**CITY OF BOULDER
CITY COUNCIL AGENDA ITEM**

Consideration of a motion to adopt proposed amendments to the Transit Village Area Plan (TVAP) connections plan and street section drawings for Pearl Parkway and Junction Place.

TVAP Transportation Connections Plan Amendment

Figure D – Plan and section views of proposed Pearl Parkway “multiway” boulevard

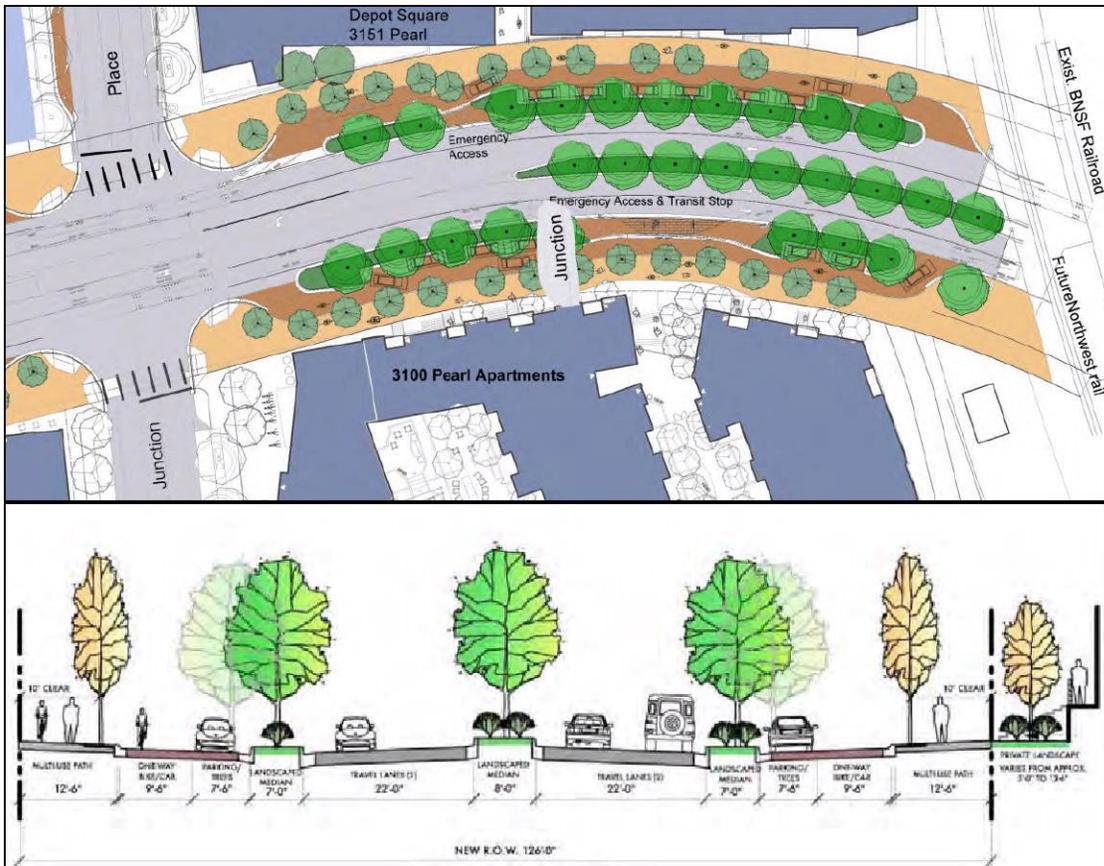
1. *Add a new boulevard cross-section for the segment of Pearl Parkway between 30th Street and the tracks.*
2. *Amend the current cross-sections and segment designations for Junction Place shown on pages 36-37 of the TVAP (See Attachment B) as follows:*

- Adjustments to the cross section width for Pearl Parkway roadway lanes, parking, etc. have resulted in creating additional space for a narrow, second row of trees at the interface between the side street and multi-use path.

- Detailed design for emergency access for the 3100 Pearl Apartments and Depot Square sites has resulted in acceptable configurations, while minimizing the impact of this access on the streetscape and landscape design. This emergency access need has been combined with proposed transit stop infrastructure on the south side of Pearl Parkway, and with a proposed drop-off area on the north side of Pearl Parkway, resulting in an efficient use of the limited space available.

- Transit Stop infrastructure has been accommodated.
- Raised treatments are planned on the side-street approach to each of the multiway boulevard segments to provide for safe vehicle speeds.

- A mountable, ADA detectable, short curb is planned between the side street and multi-use path, allowing for ease of bike movement between both features and sharing of the side street access lane by both slow-moving cars and bikes.

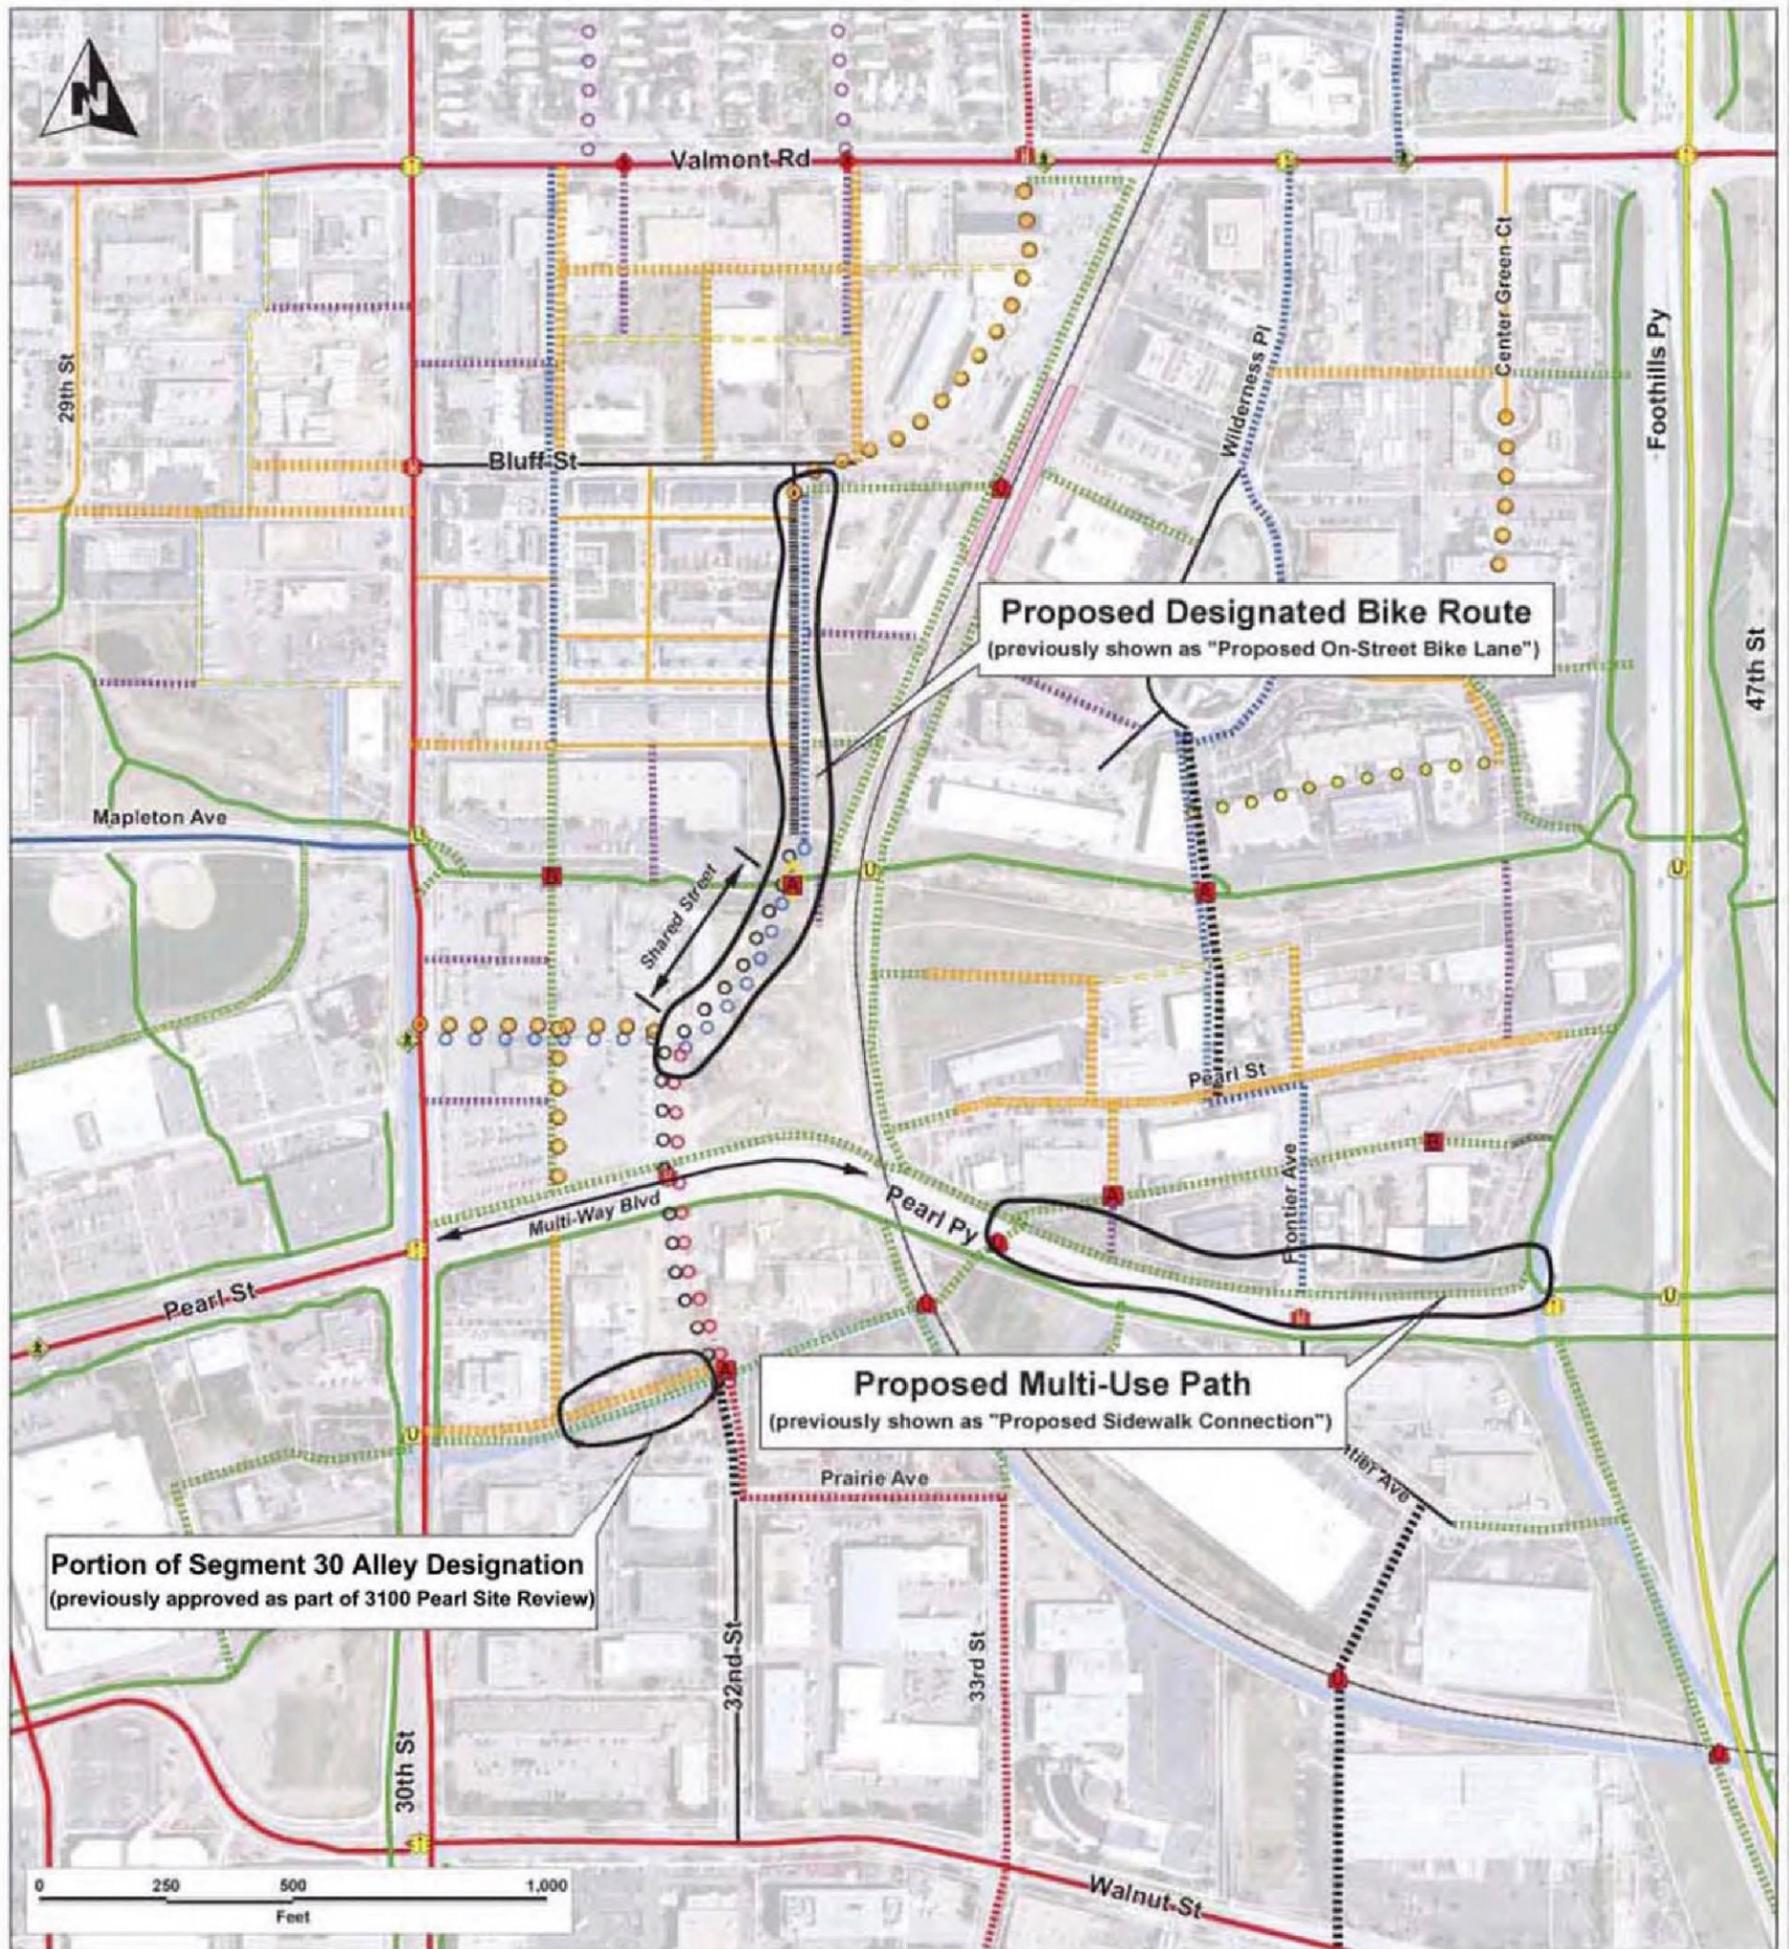
3. *Amend the current designation for Segment 30 of Junction Place in the TVAP Connections Plan for the portion on the west edge of the 3100 Pearl property, to be an alley designation rather than a local street, as approved in Site Review for 3100 Pearl Street.*

Junction Place Segment 1
 Southern Area Boundary to North Edge of Bus Facility Area **Ramp (future Spruce St)**

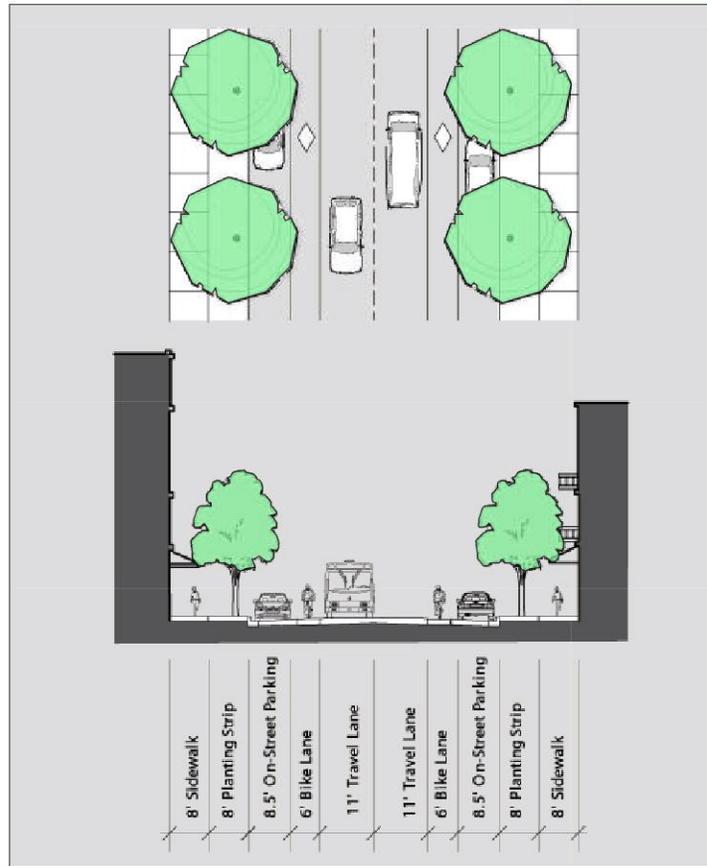
- a. *Change the north limit for Segment 1 to be the north side of the RTD bus ramp (future Spruce Street alignment), and reference the left turn lane required in the intersection with Pearl Parkway.*

For phasing and design purposes, Junction Place has been broken into ~~three~~ **four** segments. The exact alignment for each segment will be determined at the time of redevelopment of the adjacent properties through Site Review. Comparative costs and impacts to adjacent properties will be considered. Phasing, funding and cost sharing for Junction Place is addressed in the Implementation Plan.

Note: Center left turn lane at Pearl requires adjustments to cross section elements, and dedication of additional sidewalk easements at outer edges beyond shown 83' ROW.

JUNCTION PLACE SEGMENT 2
TYPICAL 'SHARED STREET' SECTION
(NORTH EDGE OF BUS RAMP TO SOUTH EDGE OF GOOSE CREEK BRIDGE - LOOKING NORTH)

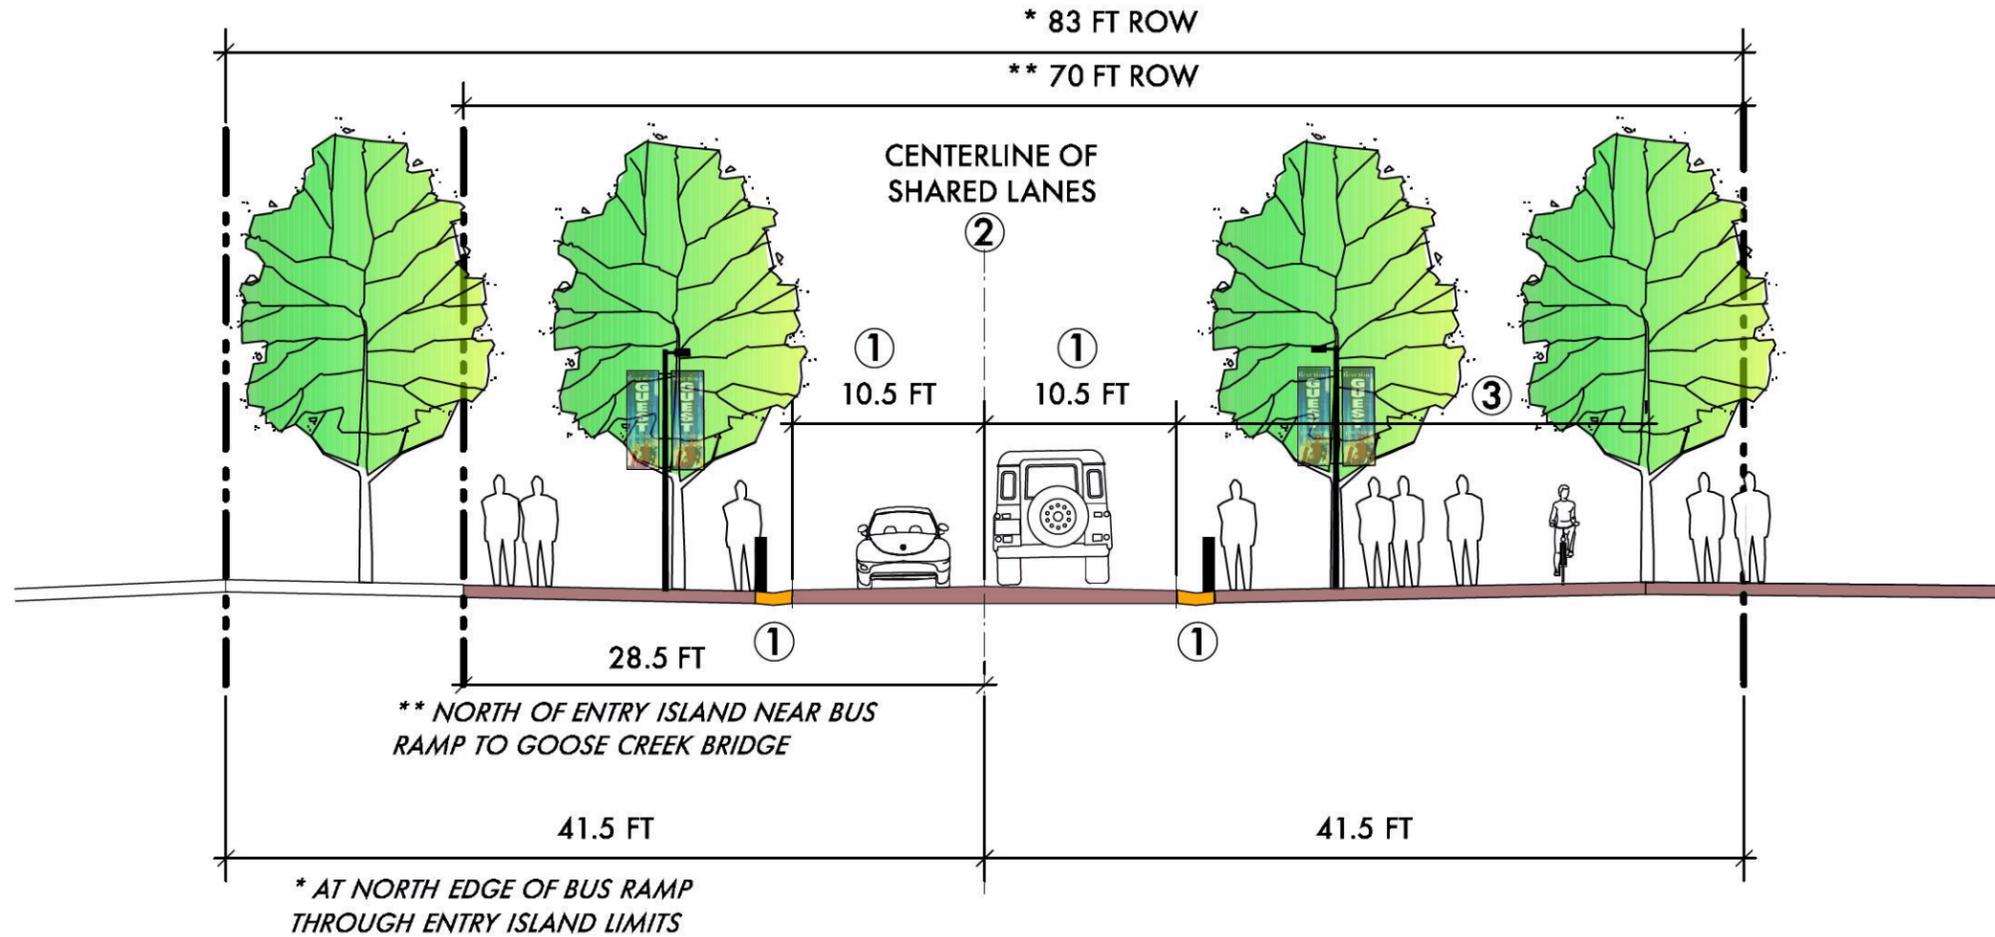
- b. *Add a new cross-section for Segment 2, and modify this segment's limits to "North side of the RTD bus ramp (future Spruce Street alignment) to the Goose Creek Bridge. Eliminate on-street parking in the newly revised Segment 2.*

Add write-up for newly designated Segment 2 from north edge of Bus Ramp (future Spruce St) to Goose Cr

- ① PLACEMENT OF BOLLARDS AND OTHER SIMILAR FURNISHINGS TO EDGES IS TO BE DETERMINED. MAINTAIN 21 FT CLEAR.
- ② CENTER MEDIAN AREA PLANNED AT SOUTH ENTRY TO SEGMENT 2 AND POSSIBLE OTHER LOCATIONS. WIDTH AND LOCATIONS TO BE DETERMINED.
- ③ DROP-OFF AREA NEAR DEPOT WILL RESULT IN MODIFICATIONS IN THIS AREA.

Junction Place Segment 3

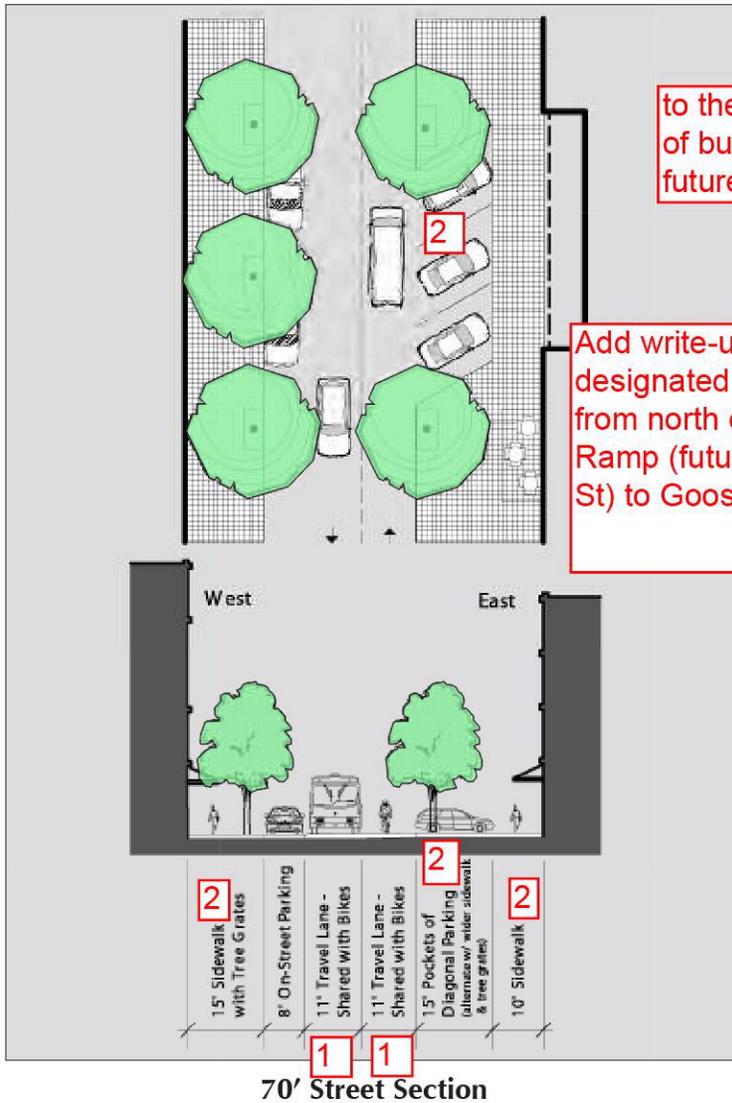
- c. *Change limits of Segment 3 to be the segment from the Goose Creek Bridge to Bluff, and reference allowable alternate parking configuration along the east side, as well as alternate sidewalk widths for both sides between the Goose Creek Bridge and Carbon Place.*

Goose Creek Bridge - North Edge of Bus Facility Area to Bluff Street

to the north edge of bus ramp at future Spruce St

Notes:
 1. Minimum travel lane width may be reduced to 10.5'.
 2. Possible parallel parking configuration may be allowed on the east side, and possible narrower sidewalk sections (both sides) may be allowed between Goose Cr and Carbon Pl consistent with approved Steel Yards P.U.D. and existing 52' ROW.

Alternative 1: Multiway Boulevard with Multi-use Path

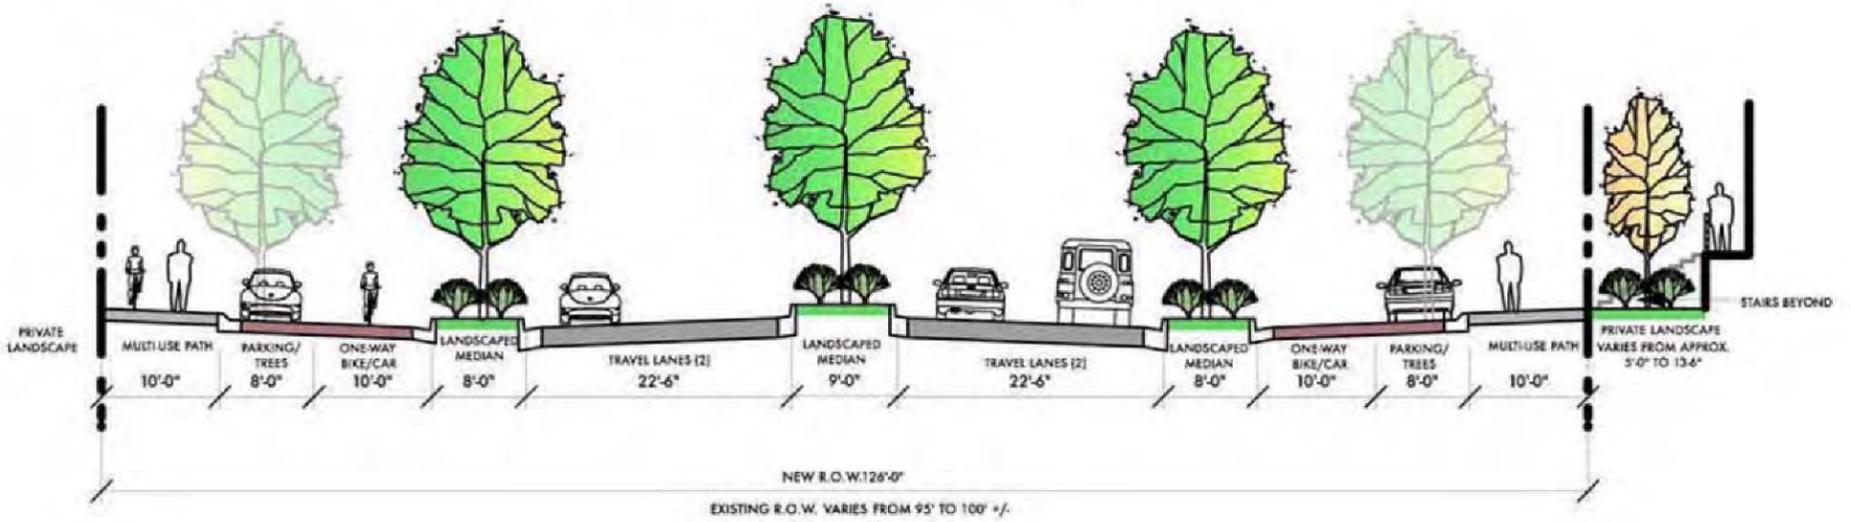
- In considering Alternative 1, folks thought the parking on the main street side was superior to the parking on the sidewalk side. Moving parking towards the main street would remove it as a conflict for bikes/peds on the MU path and would ensure that people using the parking would enter the street, generating some of the pedestrian activity that is desired.

Comment: Community Cycle favors Alternative 1A. Like the dedicated multiuse path.

Comment: Alternative 2A does not feel like the right solution for individuals with disabilities. Prefers Alternative 1A with parking closer to Pearl Parkway thru lanes.

Alternative 2B: Multiway Boulevard with Contra-flow Lane

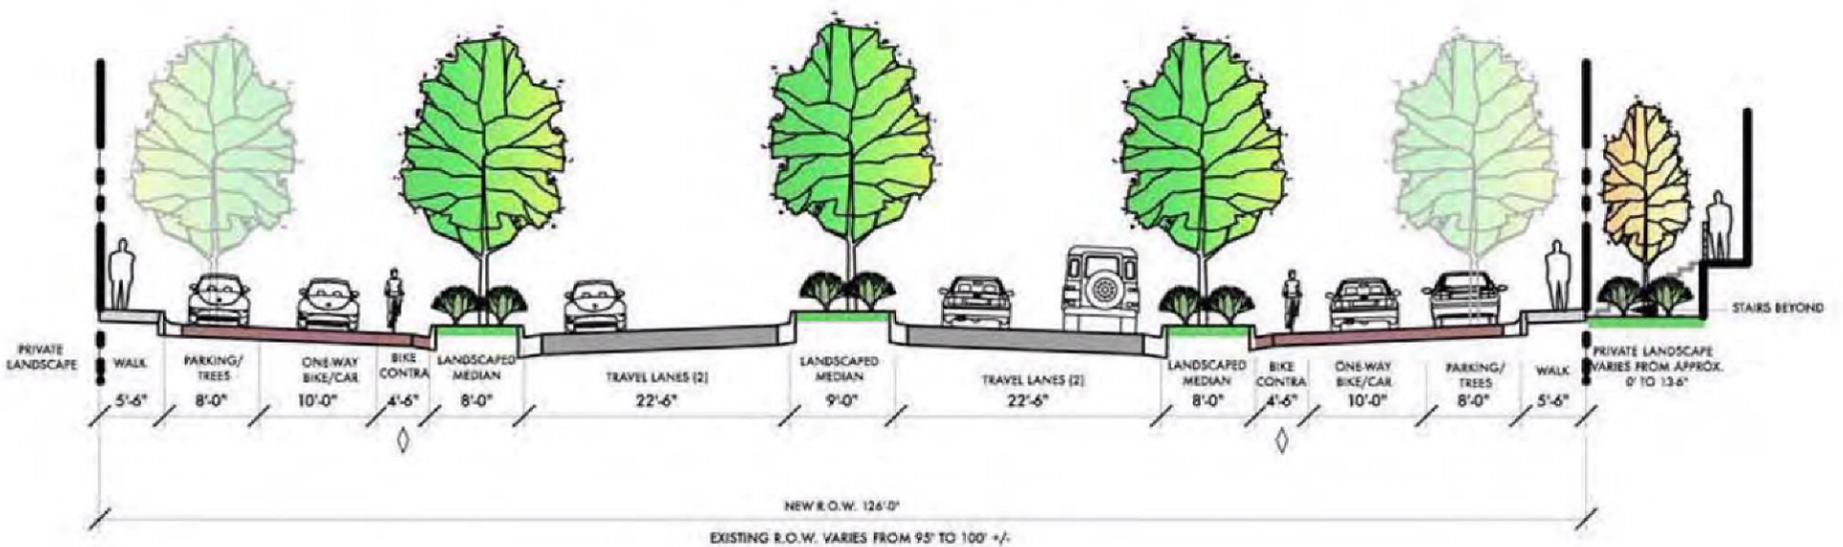
- There was a lot of concern about Alternative 2B regarding the contra flow lane. The group was concerned about motor vehicles driving in the contra flow lane, just in general or specifically when maneuvering for a parking space or when someone in a parked vehicle opens a car door.
